### **Response to Comments Submitted by the Brazos River Authority**

## Attachment A: Mapped Simsboro Transmissivity Values from the Original GAM and the Updated GAM

GMA 22 Update to The Groundwater Availability Model for the  
Central Portion of the Sparta, Queen City, and Carrizo-Wilcox Aquifers

Figure 4 Simsboro Transmissivity Field in the Modified GAM. Line A-A' marks the location between the modified and unmodified Simsboro transmissivity values along in the down dip of the Vista Ridge well field.

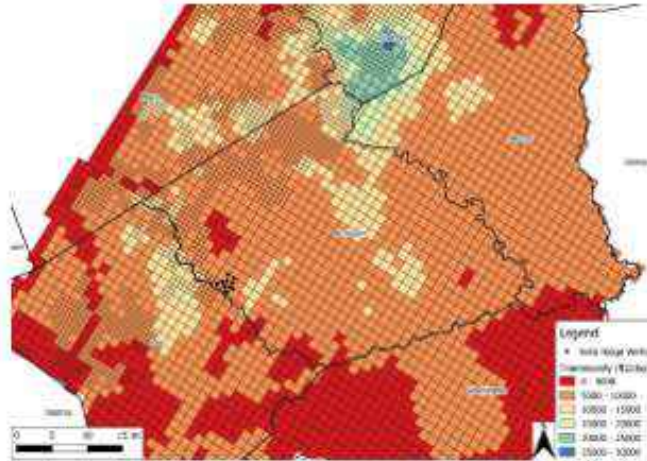
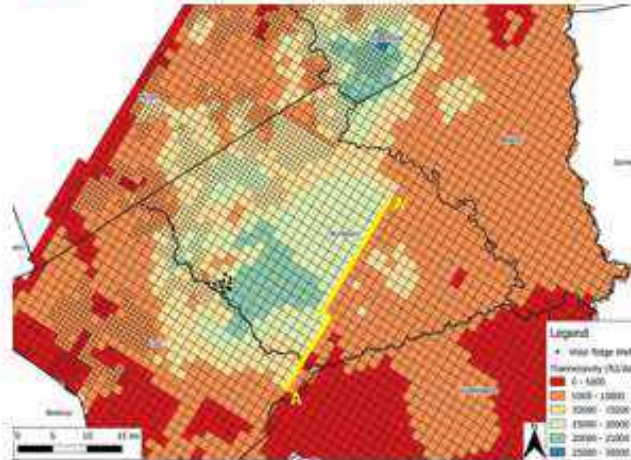
**Comment #2.** There is an apparent box-shaped transition zone between the modified and unmodified cells within the Simsboro Aquifer layer (Layer 9), which is likely a result of the parameter estimations and the methods by which those values were integrated into the original transmissivity field, that should be re-analyzed and possibly corrected.

**Response to Comment #2.** An important point associated the modified transmissivity values is that they were generated by PEST for a very different set of model calibration criteria than used by PEST to generate the unmodified transmissivity values. Thus, the magnitude and spatial variation in the modified transmissivity values should be different than for the unmodified transmissivity values. A second important point is that, along the outermost column or row where the transmissivity values were modified, the average change is less than 25% difference along three out of the four sides. A difference of less than 25% is a relatively small amount given that differences in transmissivity much larger than 25% occur across a mile distance in many regions of the unmodified transmissivity field such as in Robertson County (Attachment A, Figure 3) and among transmissivities that were calculated among the Vista Ridge Simsboro Aquifer screened wells (see Table 1 in the Updated GAM report).

Within the area contained in the box drawn around the pilot points used to modify the Simsboro transmissivity field, the transmissivity values were increased by an average multiplier of 1.7, or 70%, with the smallest and greatest changes in the updip (Northwest) and downdip (Southeast) portions of the box, respectively. Unlike updip portions of the box, where the transition between modified and unmodified transmissivity values are difficult to distinguish, across the downdip portion of the box, the transition between unmodified and modified transmissivity values is easily distinguishable. This boundary is marked by the line A-A' in Figure 4 in Attachment A.

The modified transmissivity values are about twice the values of the unmodified transmissivity value. To explain this increase, we have modified Section 3 of the report to include the following discussion.

“As part of the recalibration of the GAM, several attempts were made to reduce the amount of increase in the Simsboro transmissivity values in the vicinity of line A-A’ shown in Attachment C. These investigations showed that notable reductions in transmissivity values in the vicinity of line A - A’ adversely affected the match between the calculated transmissivity values from the aquifer pumping test and the GAM simulation. Based on these results, we deduced that the Simsboro transmissivity values in the unmodified GAM and in the vicinity of Line A-A’ and down-dip of Line A-A’ were likely a result of a combination of too great of a trend of decrease in hydraulic conductivity with depth that was built into the GAM (Young and others, 2018) and a possible underestimation of net sand thickness down dip of Line A-A’.

We did not pursue additional studies to adjust Simsboro transmissivity values down in the vicinity and downdip of Line A-A’ for several reasons. One reason is that the additional studies is beyond the scope of GMA 12’s directive to modify the GAM by adjusting the hydraulic conductivity values of the Simsboro Aquifer in the vicinity of the Vista Ridge well field. Another reason is that the pursuit of additional studies would likely prevent the completion of the modified GAM for use by GMA 12 for the current planning cycle. In addition, the GMA 12 consultants are unsure if there is sufficient hydrogeological data to properly guide the changes in the Simsboro transmissivity field down dip of Line A-A’ at this time.”
